Proposed
Amendments to the
Seton Ridge DA

Case 23746 & 22896

Feb 8, 2022

1. Case 23746: Amend Map 9Df of the Halifax MPS to remove a walkway to Bayview Road
2. Case 22896: Amend the DA to improve clarity for the developer moving forward.

Schedule C5

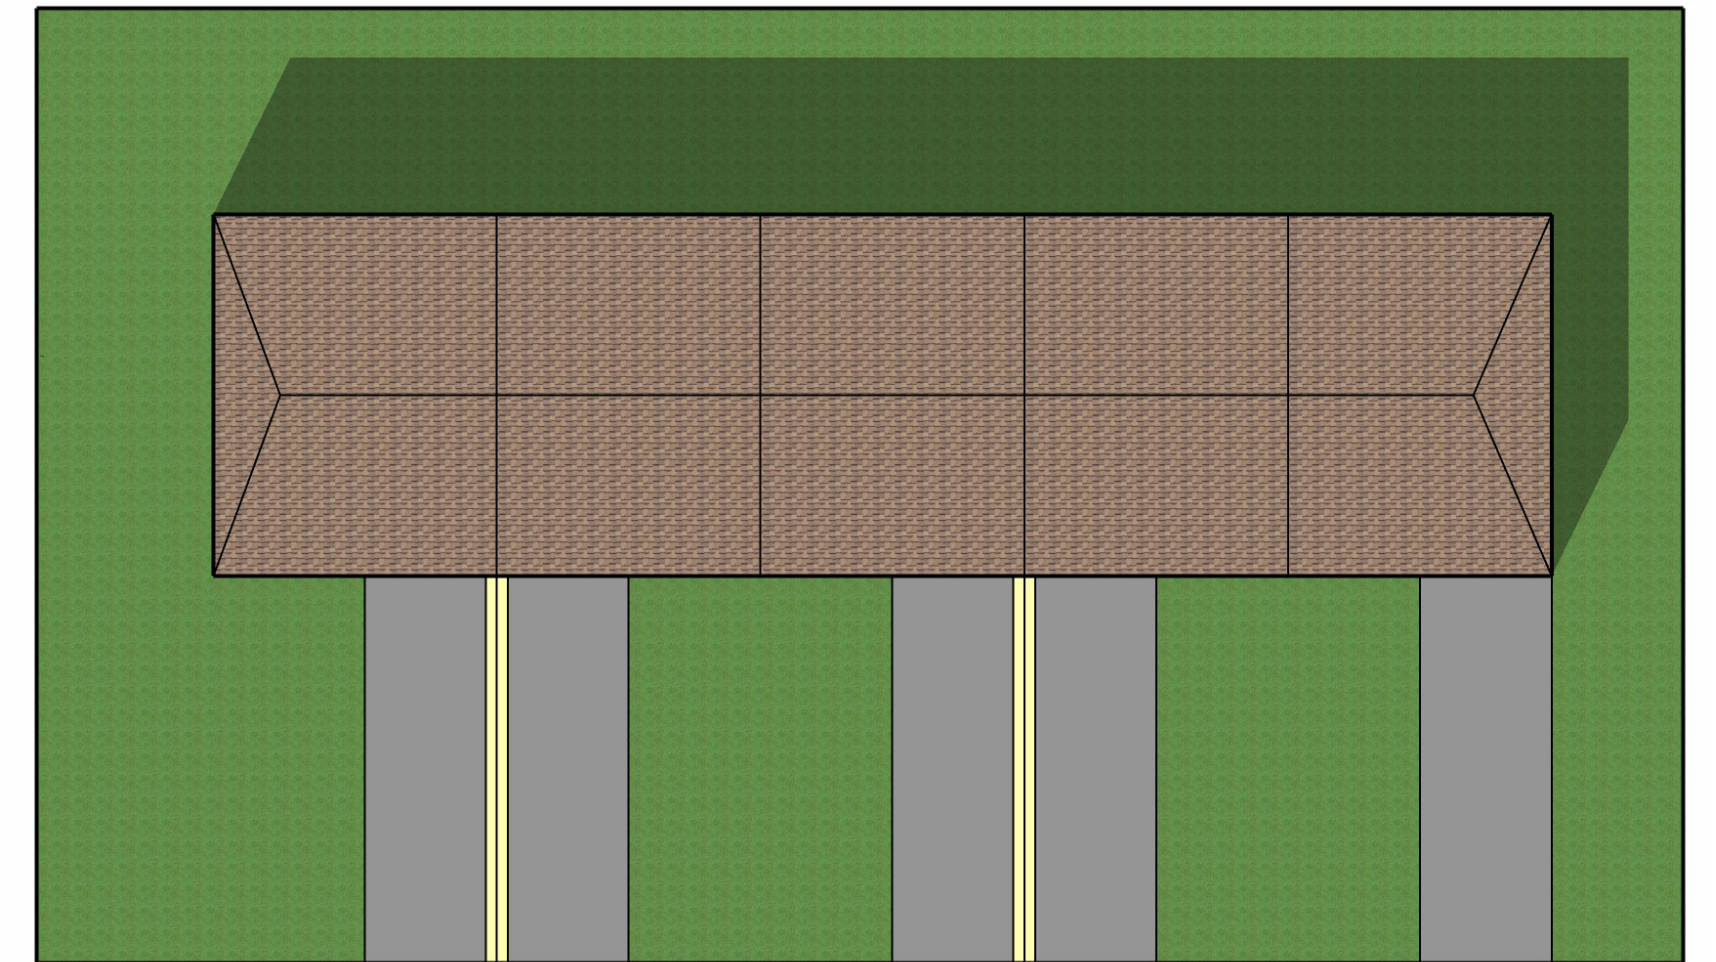
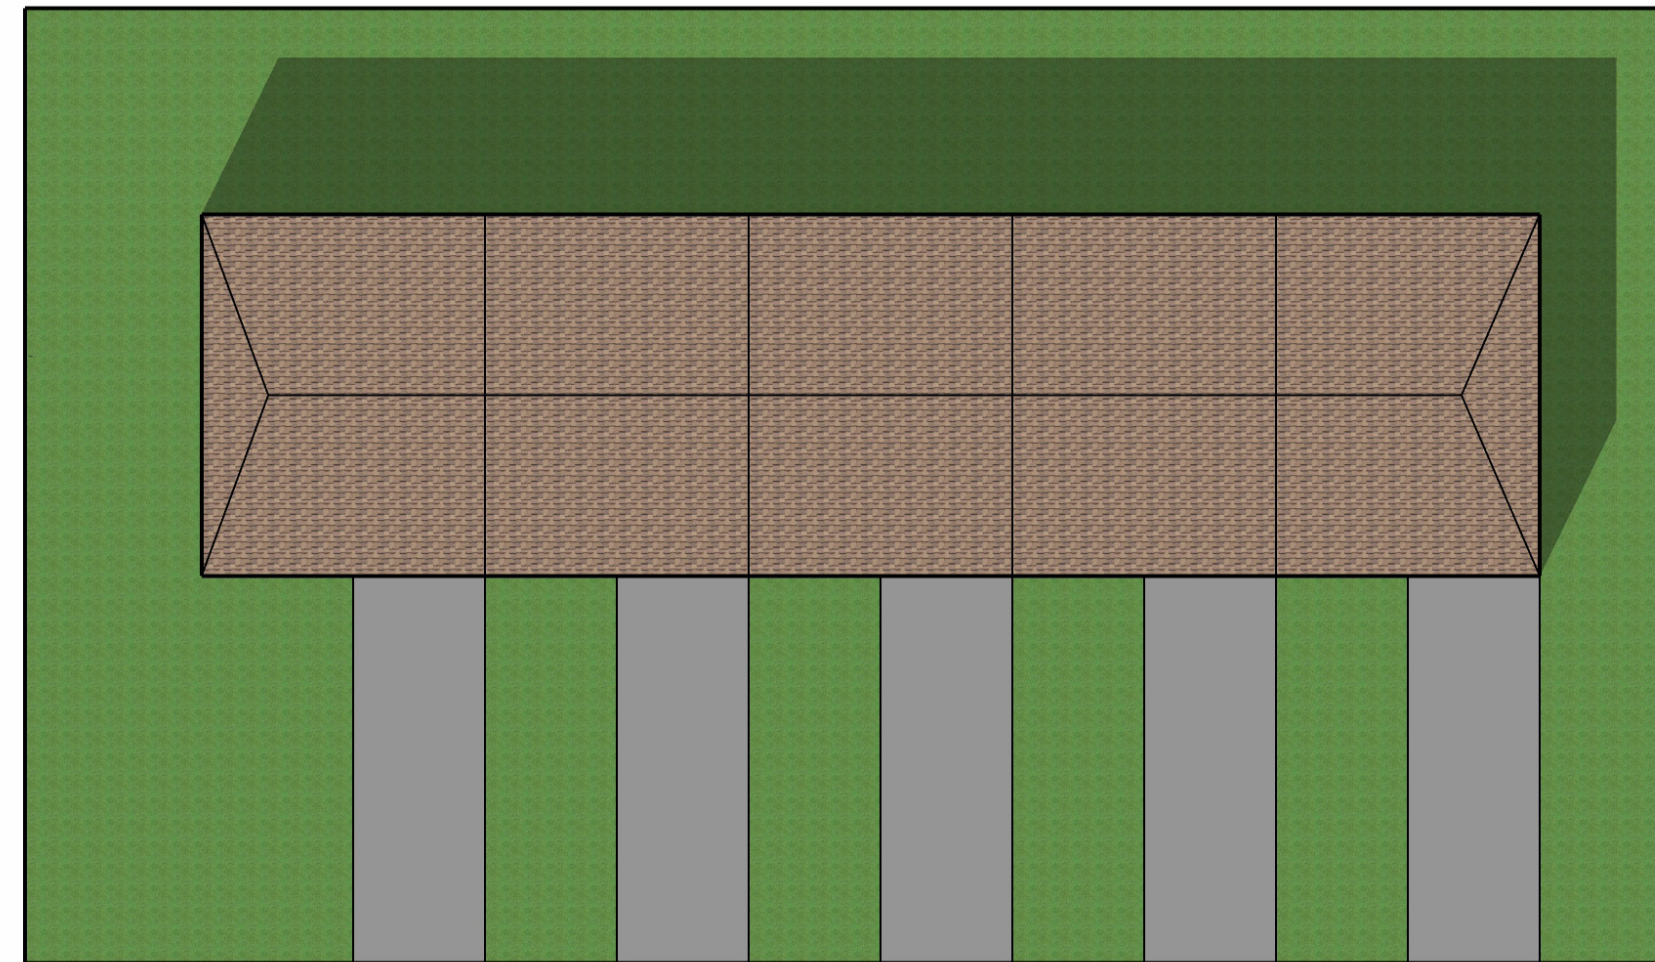
15. Where possible, driveways for townhouses and semi-detached dwellings shall be paired with a decorative strip between driveways that are a minimum of 30 cm (1 foot) in width to a maximum width of 1.5 metres (4.92 feet).

Schedule C5

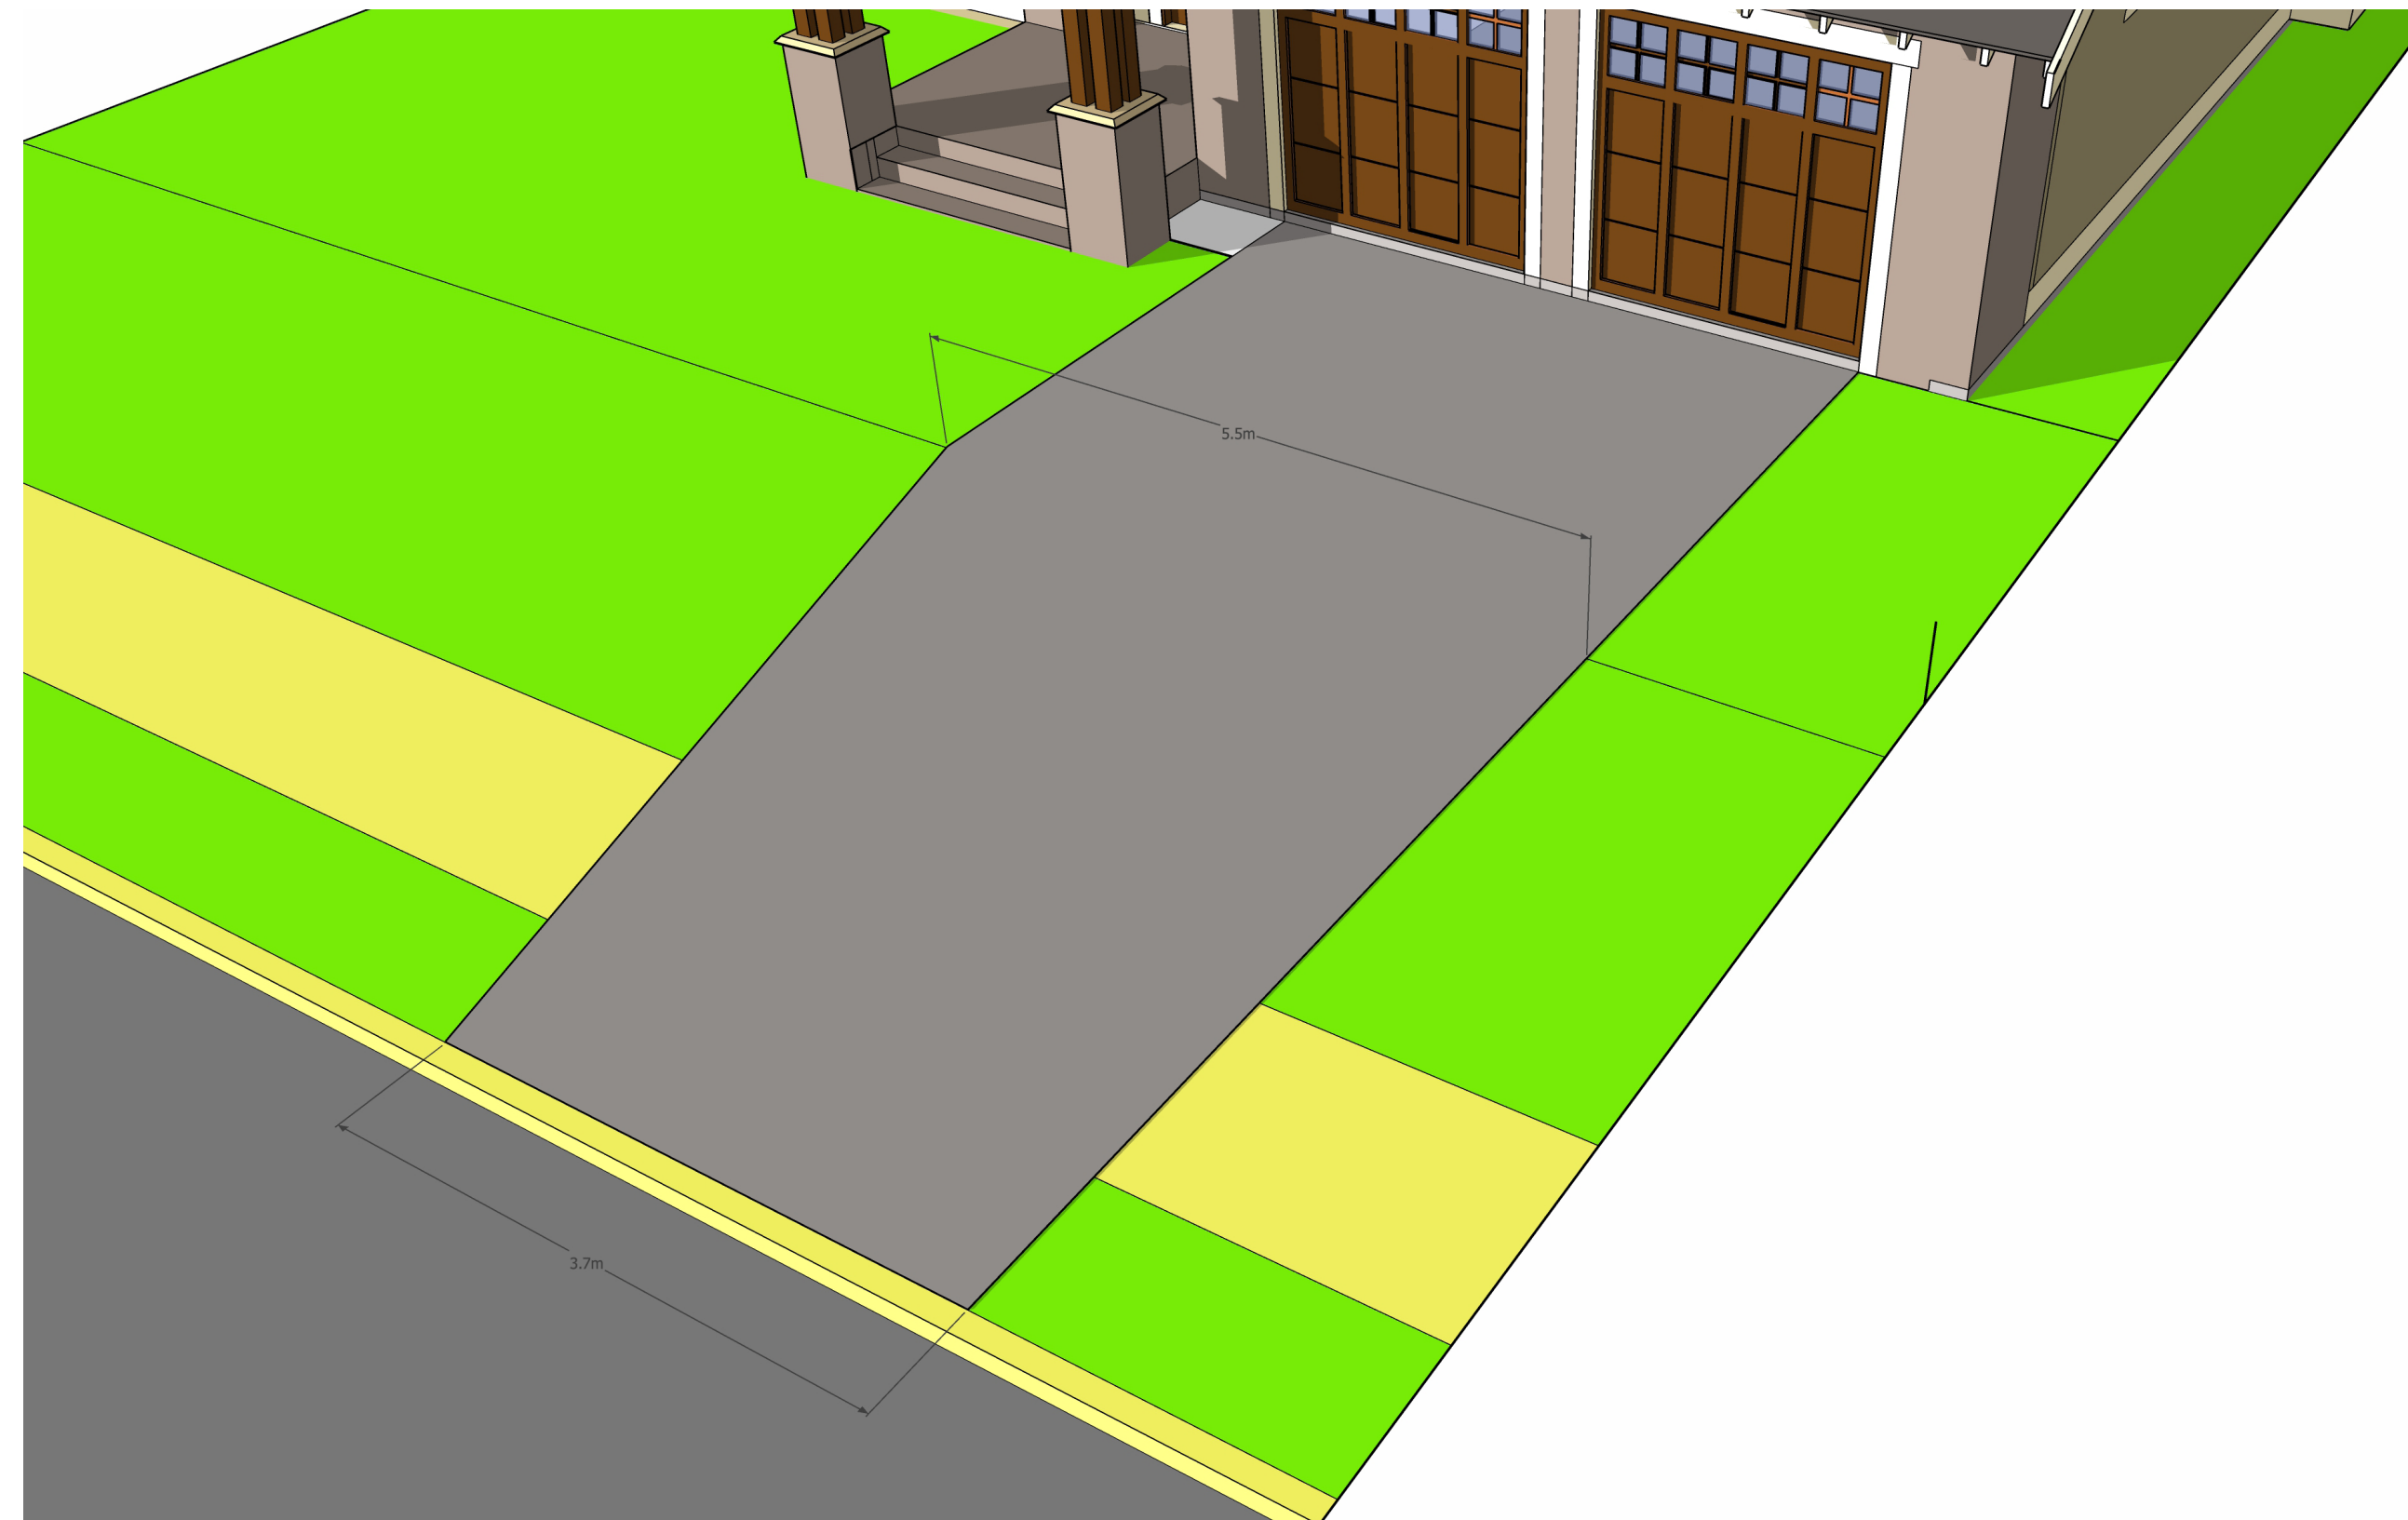
17. The maximum width of any driveway between the curb and the front property line shall be 3.66 metres (12 feet) per dwelling, and shall not exceed 4.27 metres (14 feet) in width in the front yard.
